| REV | DESCRIPTION | DRN | CHK | APP | DATE |
|-----|---|-----|-----|-----|----------|
| B | AMENDED TO BUILDING CONTROL INFORMATION REQUEST | AB | CB | RM | 05.09.25 |

Project
20 Ashley Croft
Royston

Drawing Title
PROPOSED NEW GARAGE
CONSTRUCTION DETAILS

| Name | Date | Scale | ASSHOWN |
|-----------------------------|---------------|----------|---------|
| Drawing No. AB/10054/004 | Revision B | | |

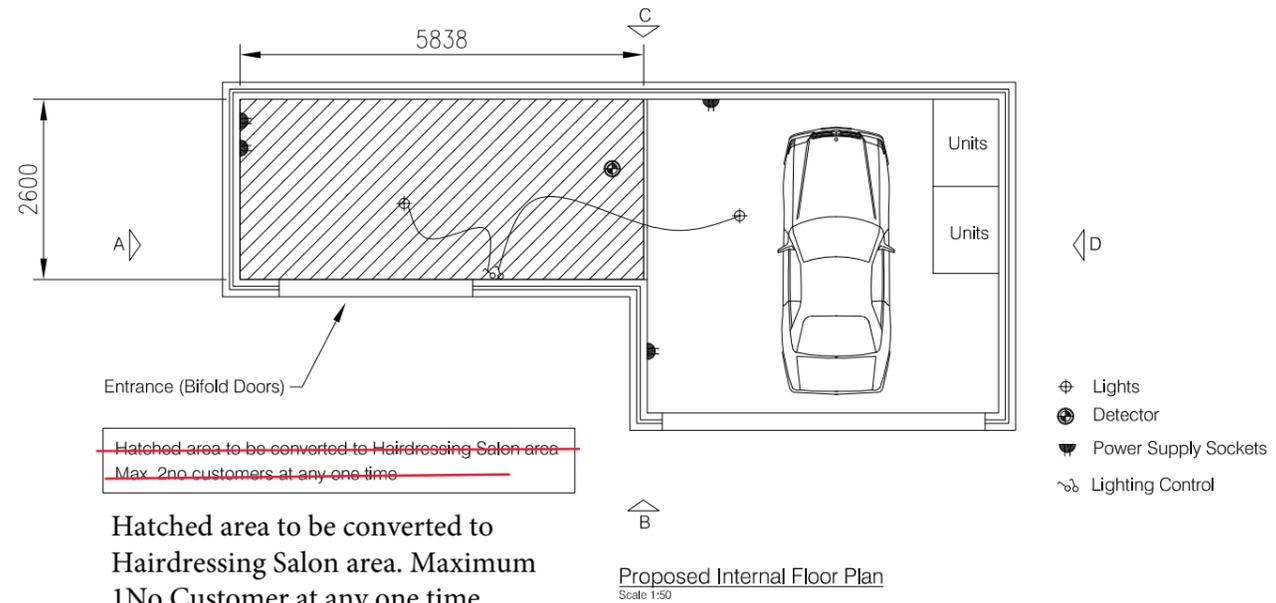
~~Hatched area to be converted to Hairdressing Salon area
Max 2no customers at any one time~~

Hatched area to be converted to Hairdressing Salon area. Maximum 1 No Customer at any one time.
